ADDENDUM NO. 1

August 7, 2026

Parking Lot Expansion

Upper Valley Career Center
8811 Career Drive
Piqua, Ohio 45356

Design: NDT	Proj: 26143
Draw: NDT	Dwg:
Check: SRF	Tab:
Scale: SEE SHEET	
Date: 07.17.2026	
Sheet:	
SOUTH SITE PLAN	
Sheet No.: C-2.0

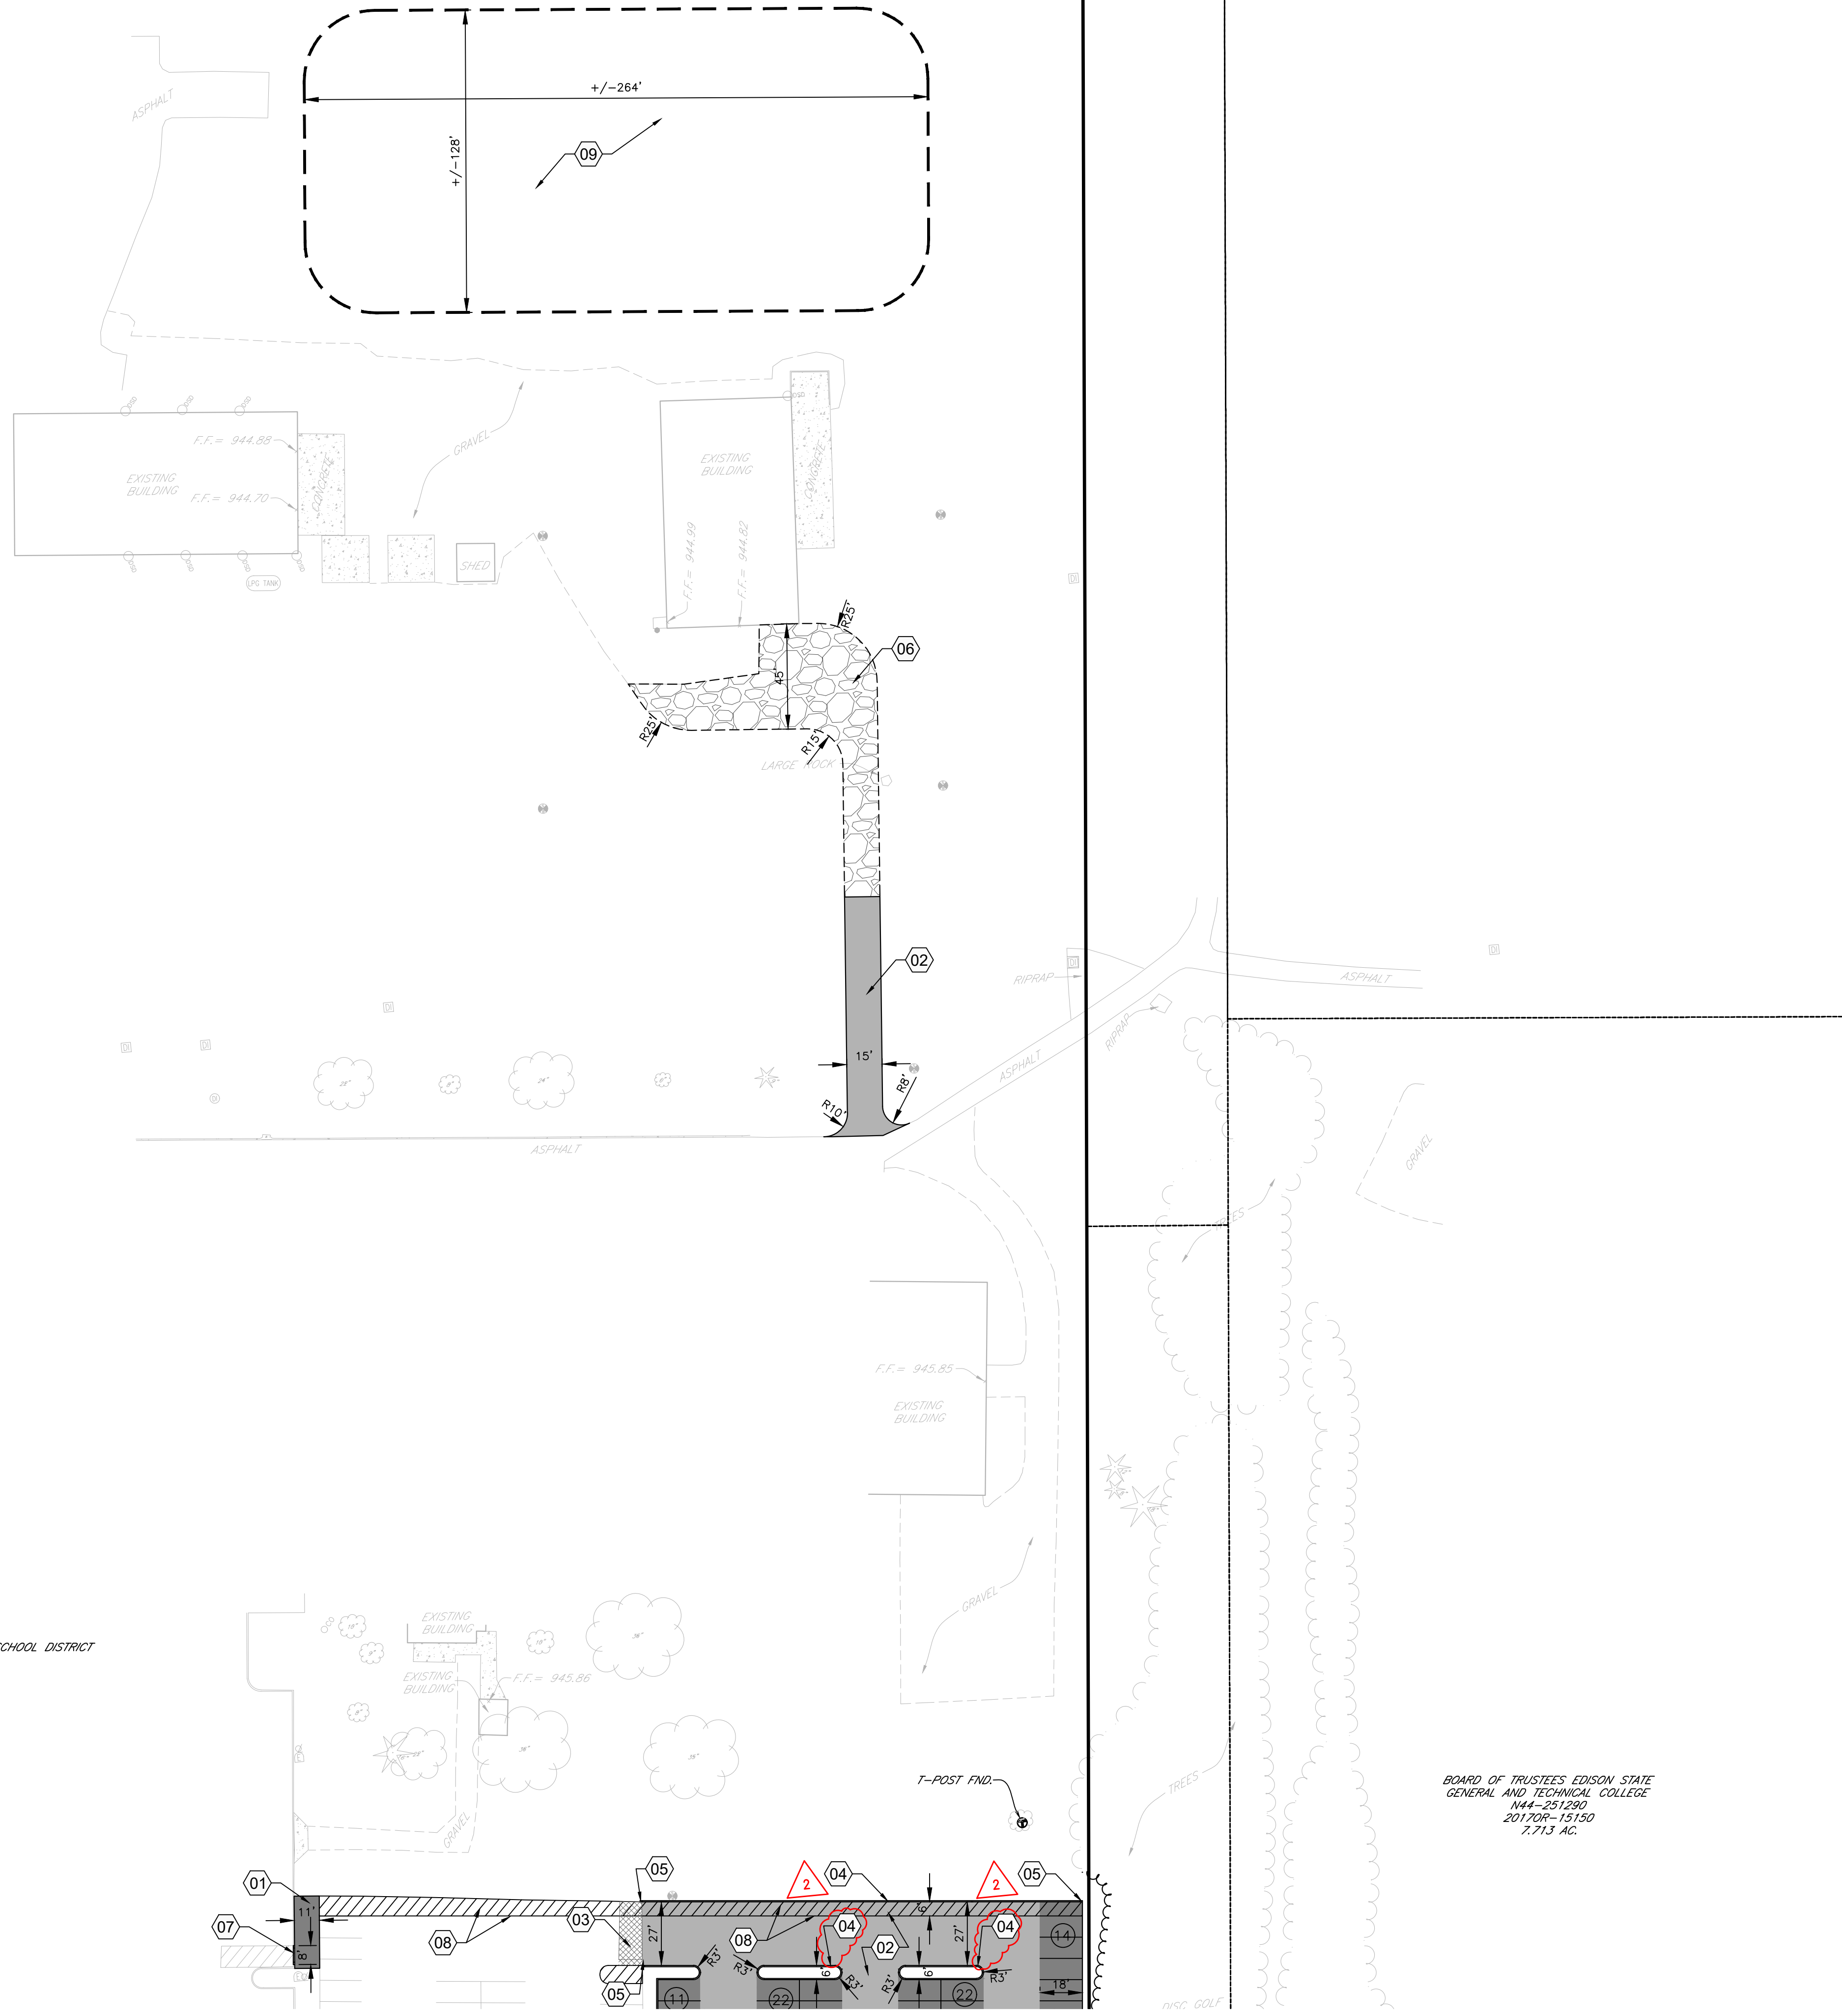
- 3.1 Sheet C-2.0 – Added curb islands in the interior parking lot area per owner request.
- 3.2 Sheet C-2.1 – Overlapped area on this sheet shows items described on sheet C-2.0.

Design: NDT	Proj: 26143
Draw: NDT	Dwg:
Check: SRF	Tab:
Scale: SEE SHEET	
Date: 07.17.2026	
Sheet: SOUTH GRADING PLAN	
Sheet No.: C-3.0

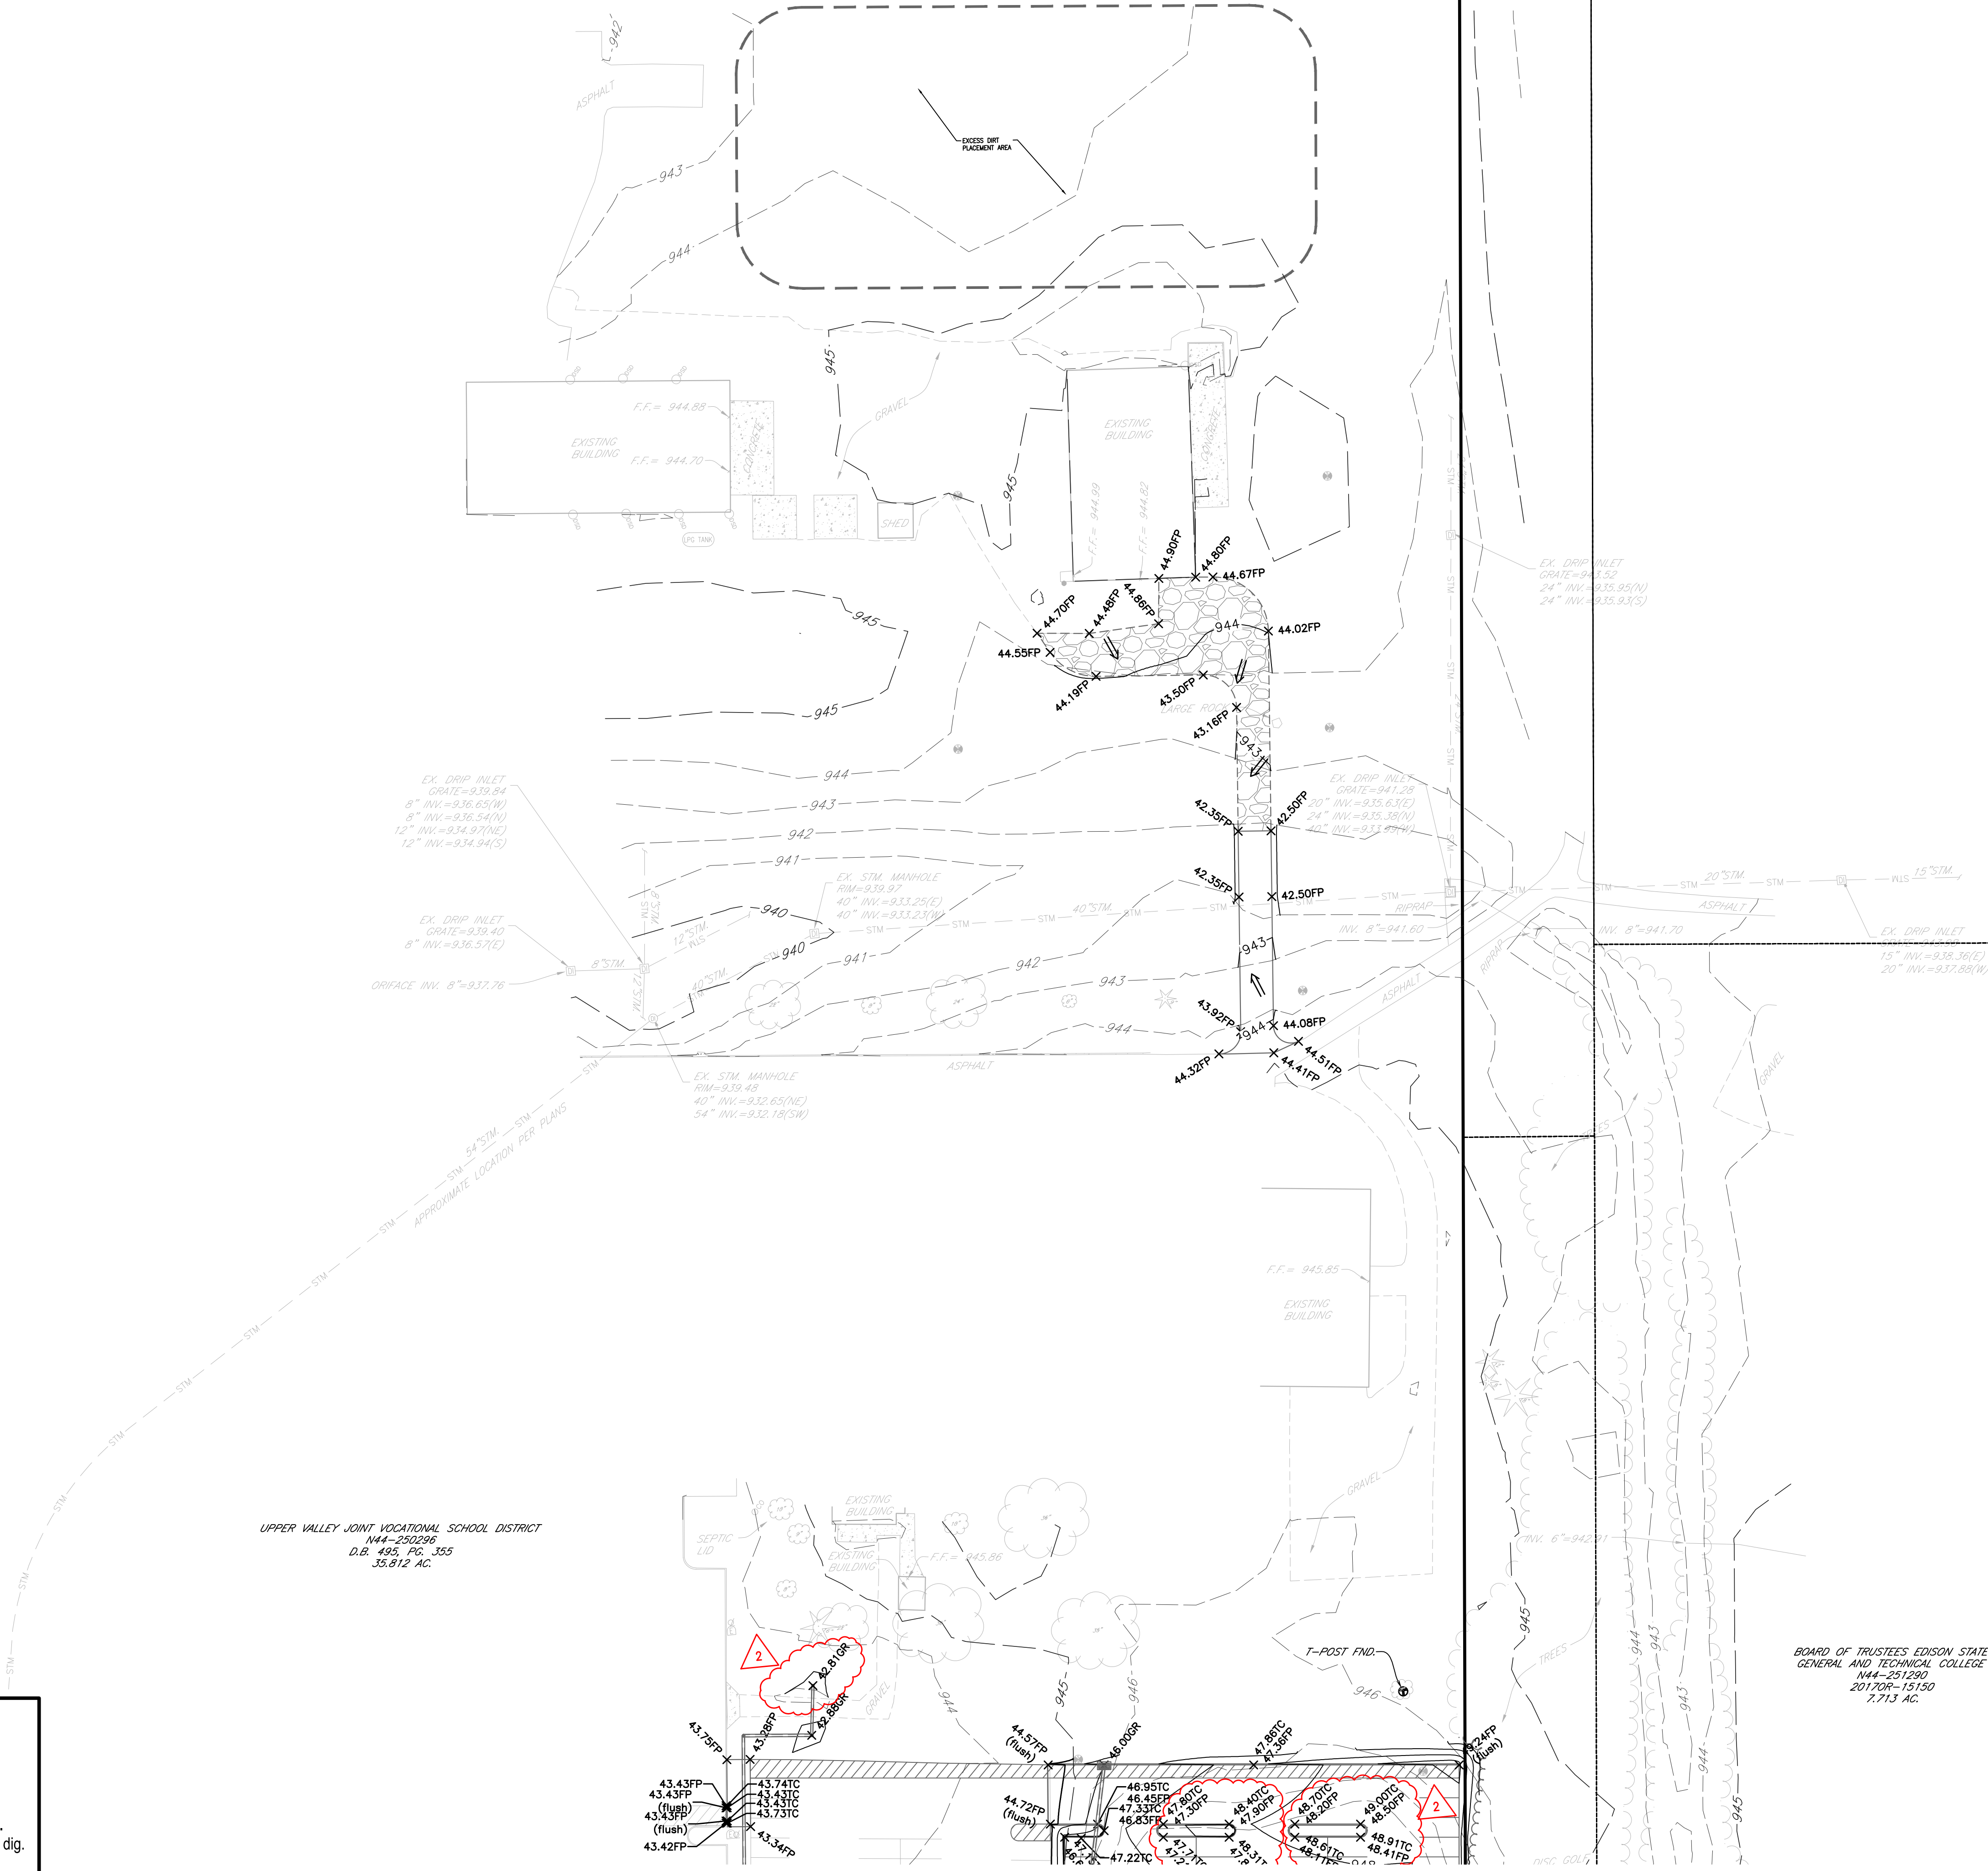
- 3.3 Sheet C-3.0 – Show new grading for interior parking lot islands. Added additional yard drain north of gravel drive.
- 3.4 Sheet C-3.1 – Overlapped area on this sheet shows items described on sheet C-3.0.

Design: NDT	Proj: 26143
Draw: NDT	Dwg:
Check: SRF	Tab:
Scale: SEE SHEET	
Date: 07.17.2026	
Sheet: UTILITY PLAN	
Sheet No.: C-4.0

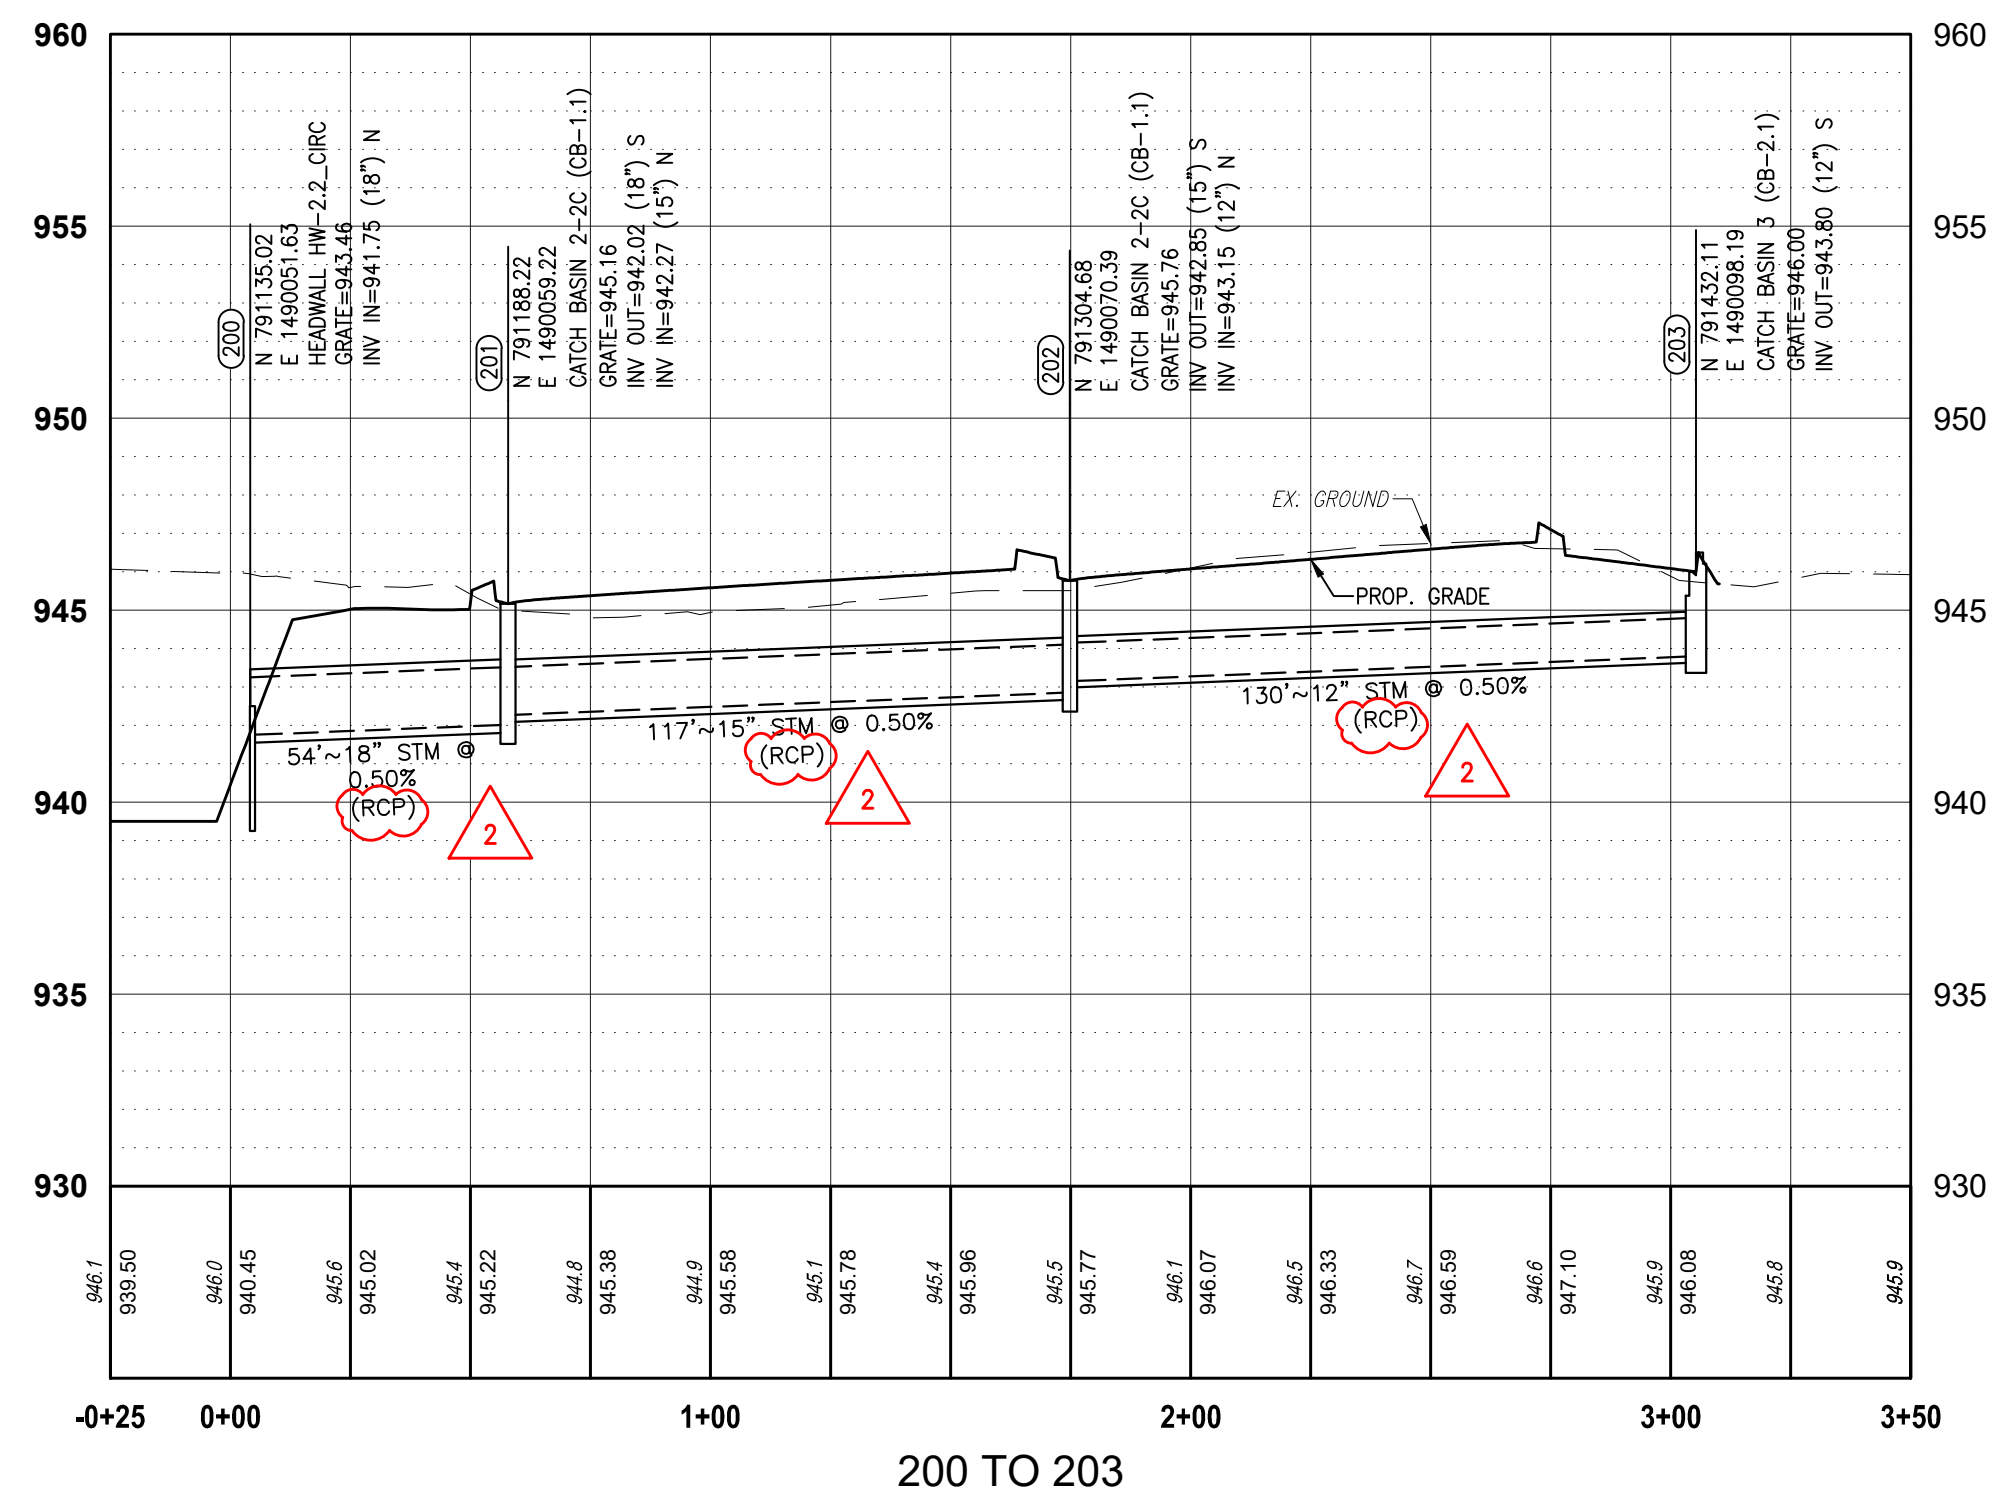
- 3.5 Sheet C-4.0 – Added one additional yard drain to north side of gravel drive. Added one 12" storm cleanout west of structure 101-C. Called for piping between structure 203 and the pond to be "RCP". Added callout number "08" for the Storm Cleanout. Added cleanout symbol to the utility legend.
